AMENDMENT NO. 001

This amendment is raised to answer Bidder's questions.

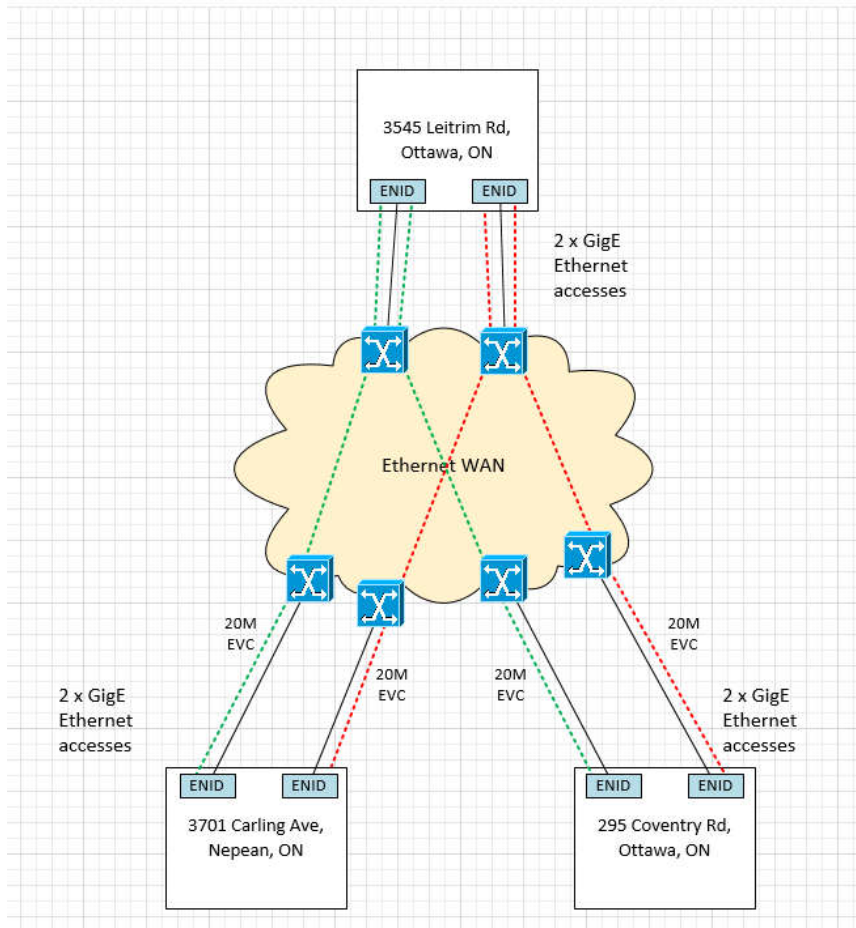
Based on the description in the RFP our understanding is that DND is requesting the following:

- Redundant point-to-point 20M EVPL connections from Leitrim to Coventry
No, not at this time. Only if 99.999% SLA is asked for in the future. Add Move Changes clause
- Redundant point-to-point 20M EVPL connections from Leitrim to Shirley's Bay
No, not at this time. Only if 99.999% SLA is asked for in the future. Add Move Changes clause
- Redundant GigE Ethernet access circuits at all three sites. At a minimum, you require that the two circuits in each HA pair of circuits must home to diverse Ethernet edge switches in the provider's network.
Only in Leitrim, Only if 99.999% SLA is asked for in the future. Add Move Changes clause

- We assume two GigE access circuits only will be delivered to Leitrim and therefore each of these accesses will be a point-to-multipoint connection as shown in the diagram below.
Correct. For Future use, Vlan tag separation between the services. Add Move Changes clause
- At each site each pair of Ethernet accesses will be configured as an active/standby HA pair
No, not at this time. Only if 99.999% SLA is asked for in the future.
- Each access will terminate on a separate CPE device supplied by the service provider.
In Leitrim at the moment, possible in the future. Add Move Changes clause

1. Please confirm this is correct or clarify the requirements.
See above responses in Red.
2. Regarding the active/standby requirement, will failover be handled on DND devices or do require layer-2 failover functionality to be provided by the service provider?
If 99.999% SLA is asked for in the future, DND eqpt will handle the Layer 2 Failover functionality.

See above for DND's comments and answers in Red for Question 3 answers.
